IACS CSR/BC RCP3 の採択について

No. TEC-0748  
発行日 2008年9月25日

1. Common Structural Rules for Bulk Carriers, January 2006, Rule Change Proposal 3

## **Rule Change Proposal 3 (Ch 8 Sec 2, 2.3 Equivalent notch stress range)**

Fig. 3.1 Hot spot stress range and hot spot mean stress

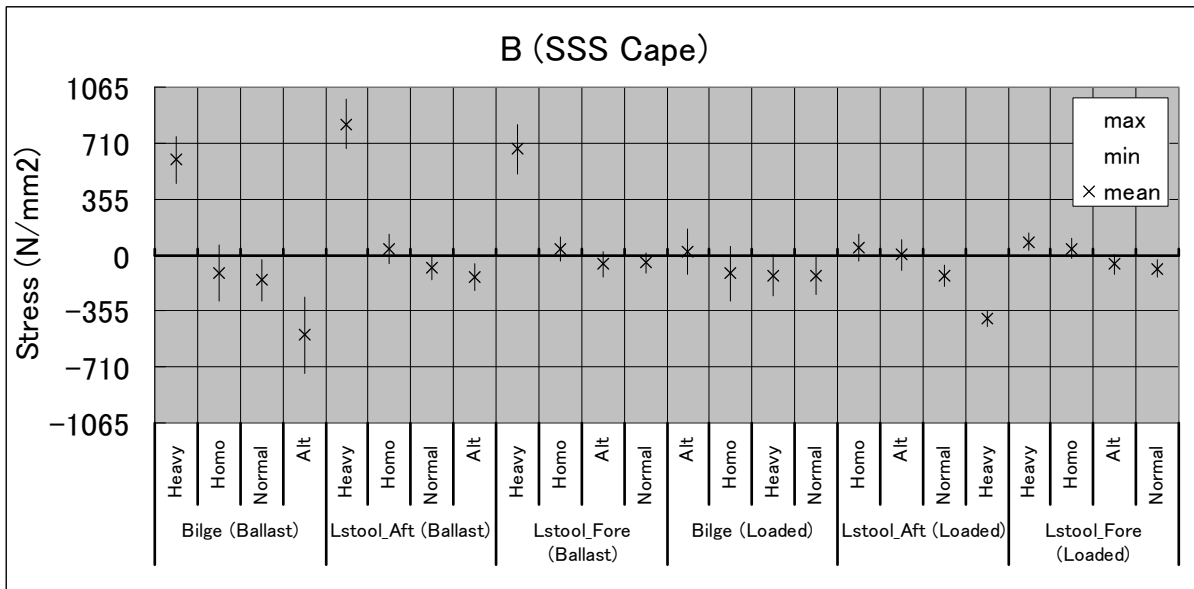
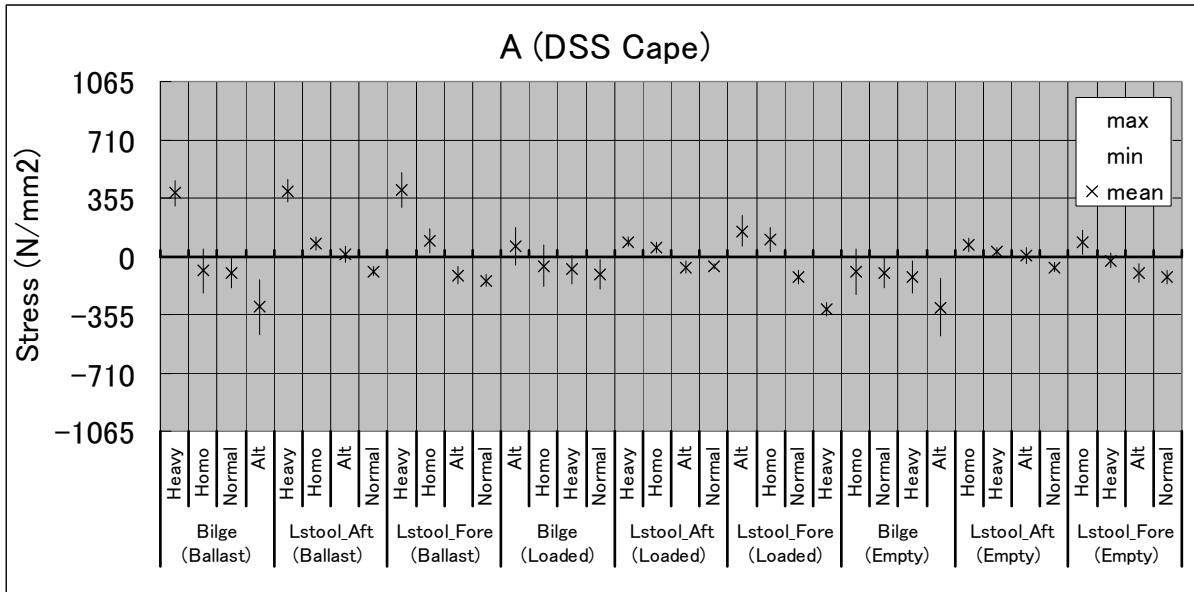
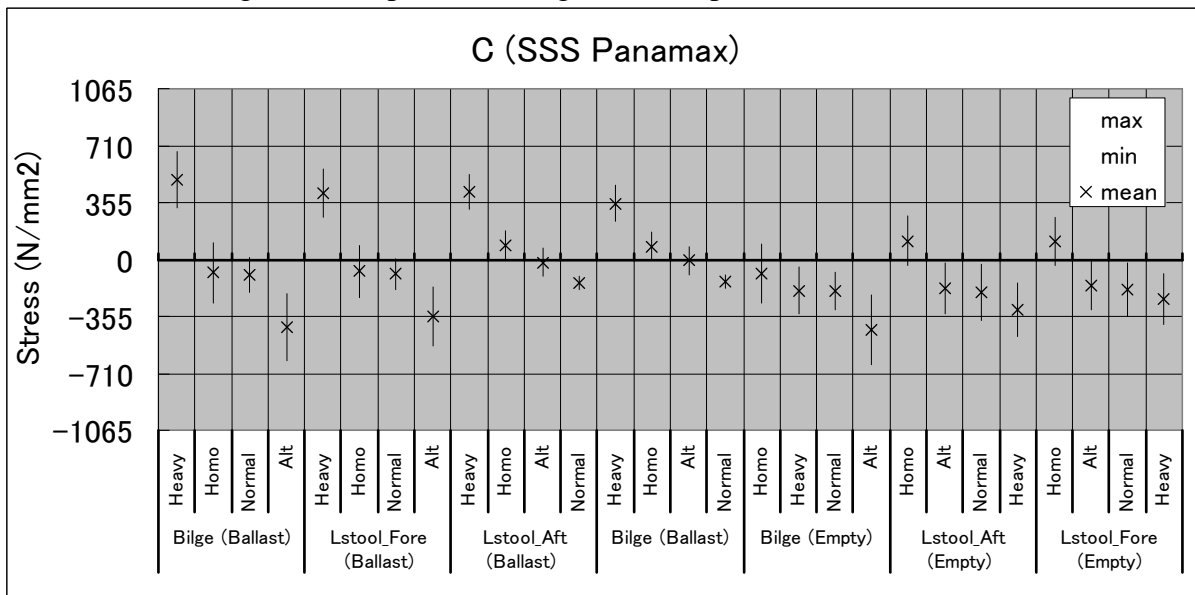
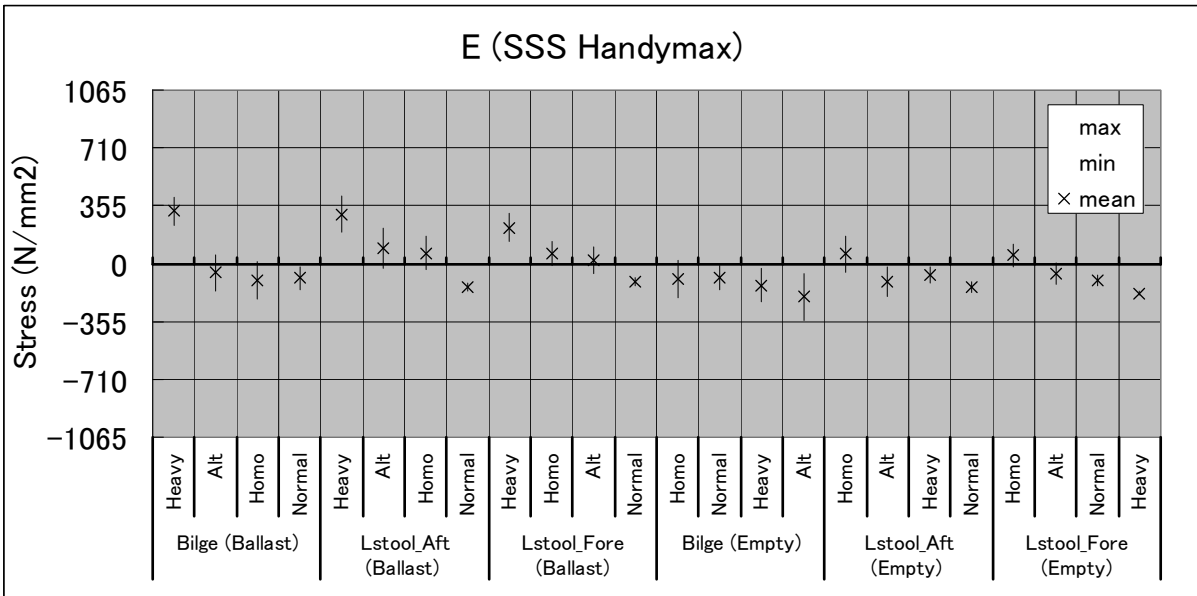
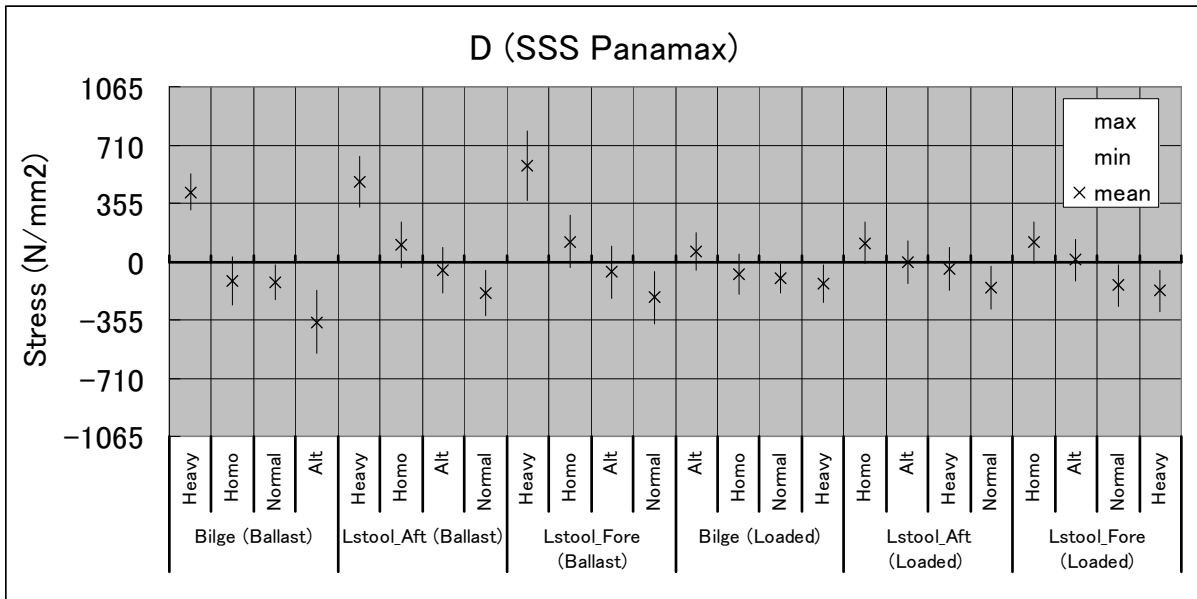
The equivalent hot spot stress range and mean stress obtained by FEA are shown in Figure 3.1

- (1) There is no effect on the cumulative fatigue damage at the fatigue assessment points in ballast holds where there was high tensional mean stress.
- (2) In cargo holds other than ballast holds, the cumulative fatigue damage at the fatigue assessment points was less than that of the current CSR, when there was compressive or low tensional mean stress and the hot spot stress range was large.
- (3) The relative tendency of the cumulative fatigue damage at the fatigue assessment points in ballast holds and other holds was consistent with the damage record specified in the Appendix.
- (4) The cumulative fatigue damage with grinding was about 60% of that without grinding.

Fig. 3.2 Cumulative fatigue damage

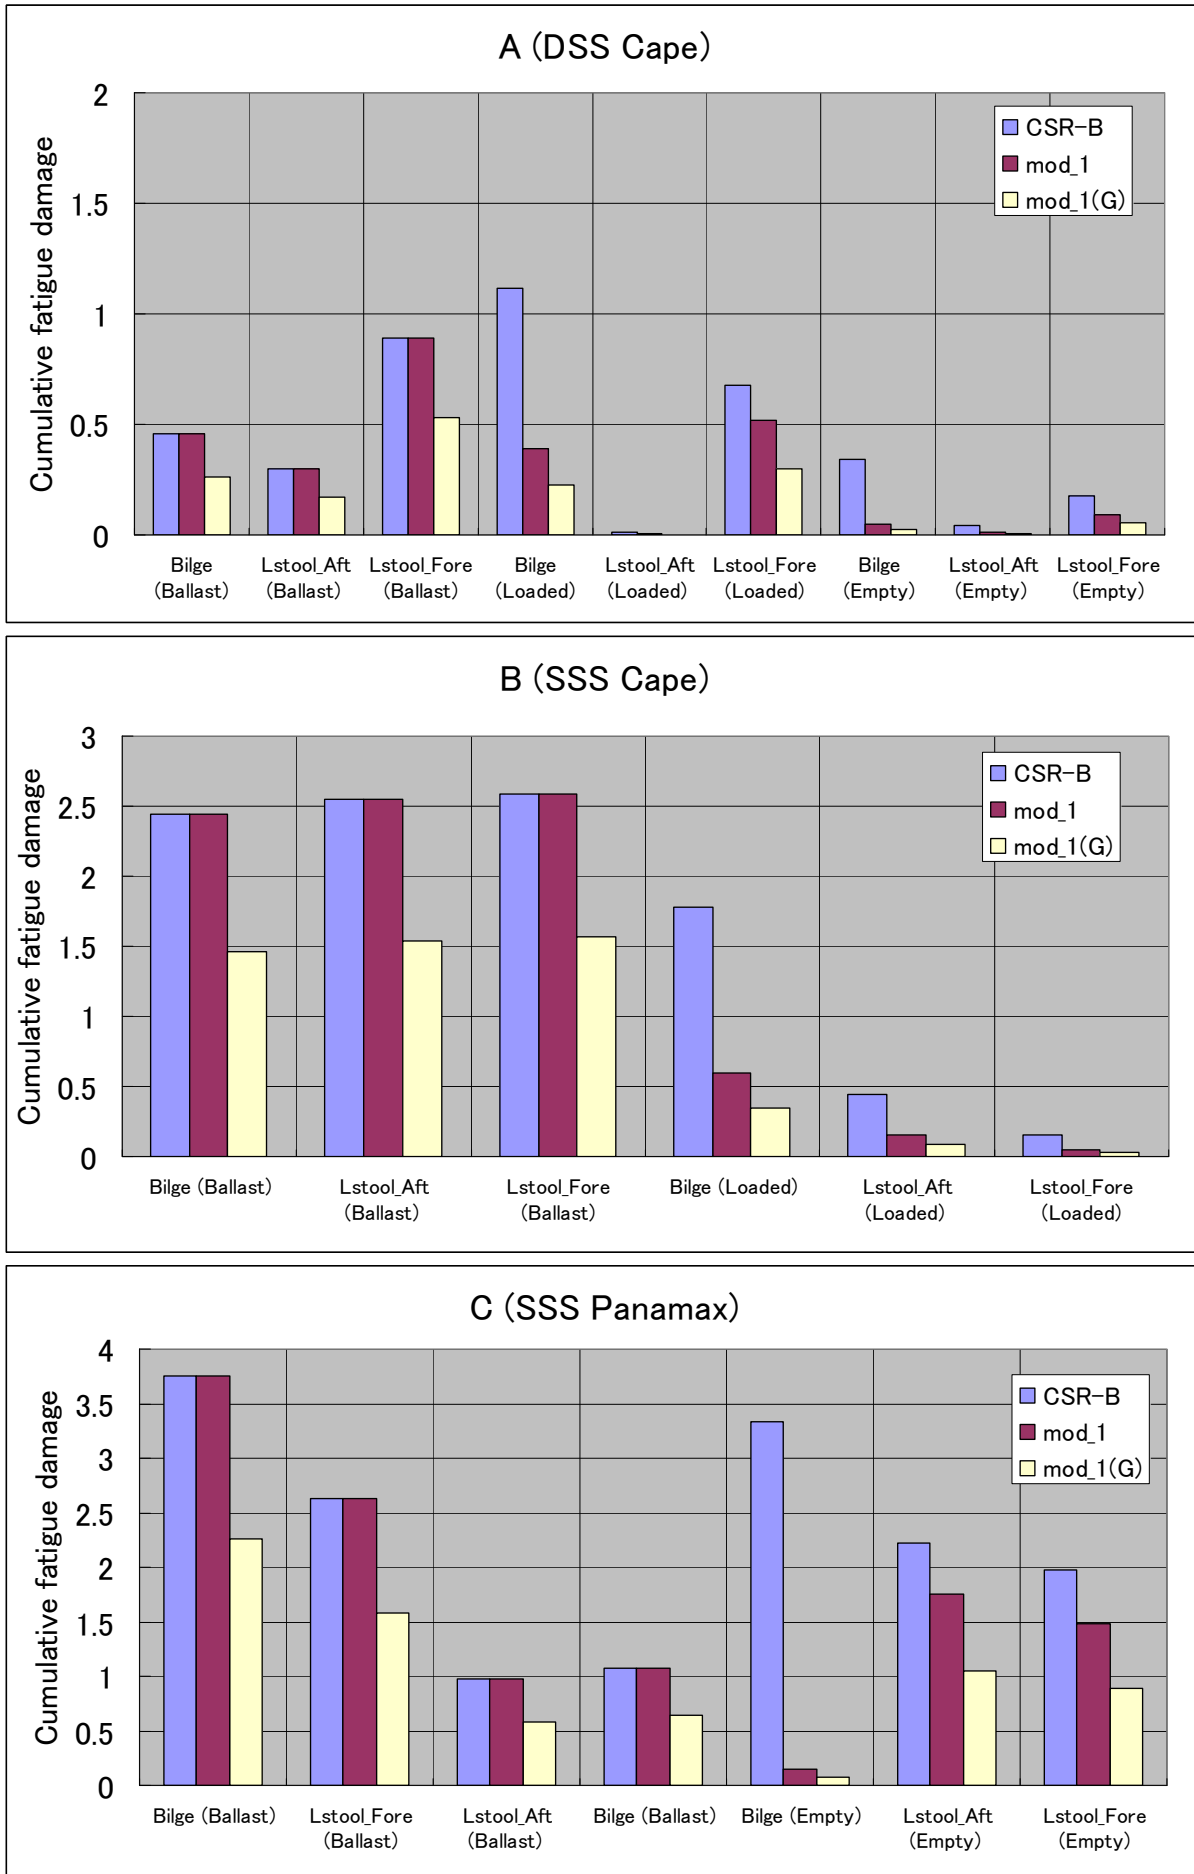
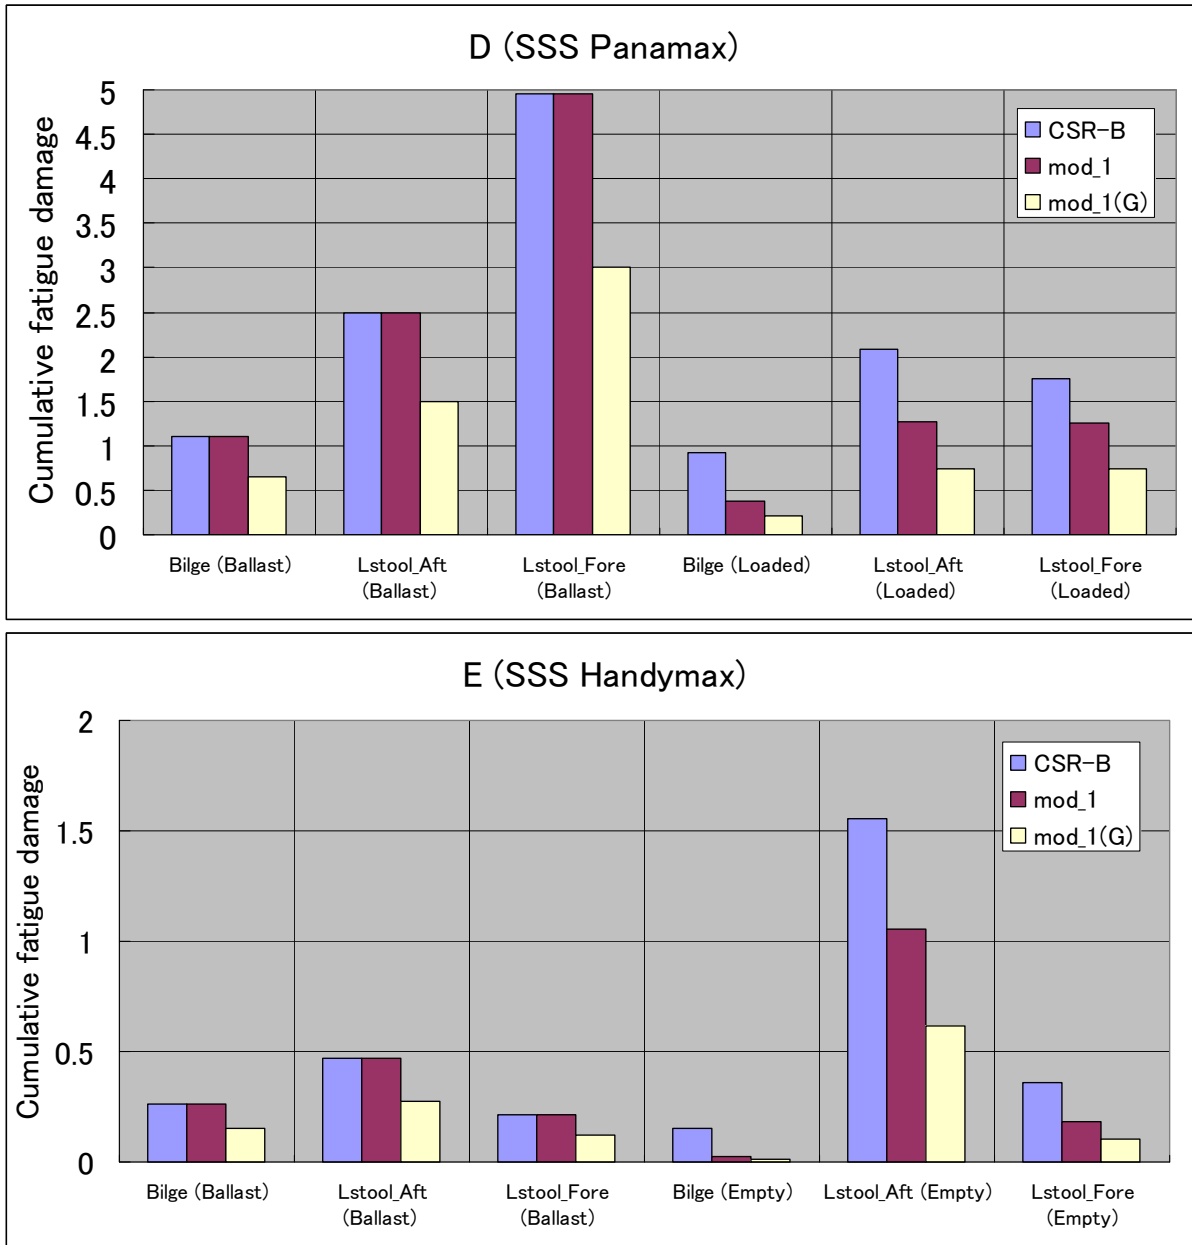
- (1) The cumulative fatigue damage according to the current CSR
- (2)(a) The cumulative fatigue damage according to the corrected formulae in 2.1 (“mod\_1” in Figure 3.2)
- (b) The cumulative fatigue damage according to the corrected formulae in 2.1 with the effect of grinding in 2.2 (“mod\_1(G) in Figure 3.2)

The results of the cumulative fatigue damage are shown in Figure 3.2.

From the results in Figure 3.2, the following can be said about the corrected formulae in 2.1.

Fig. A1 Illustration of the relationship of  $\sigma_{res}$ ,  $\sigma_{mean}$  and  $\sigma_S$

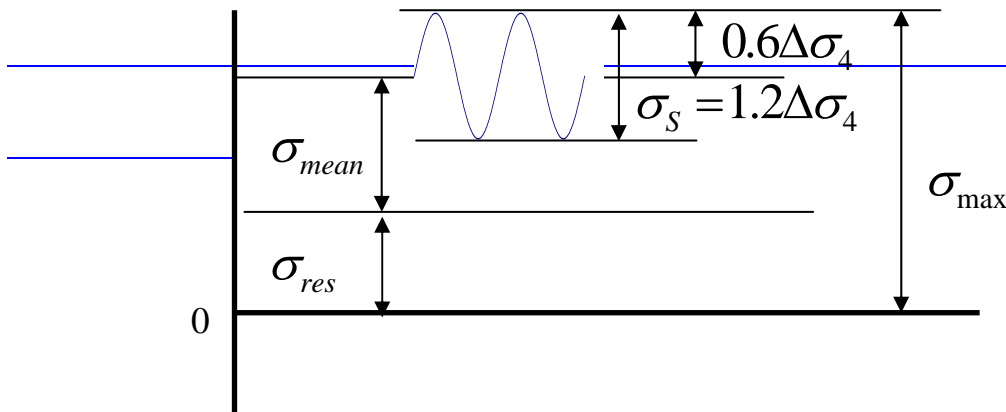
The model regarding initial residual stresses  $\sigma_{res}$ , mean stresses  $\sigma_{mean}$  and  $\sigma_s$  can be illustrated as given in Fig. A1 and  $\sigma_{max}$  is used, in order to evaluate any shake-down effects.

$$\sigma_{max} = \sigma_{res} + \sigma_{mean} + 0.5\sigma_s = \sigma_{res} + \sigma_{mean} + 0.6\Delta\sigma_4$$
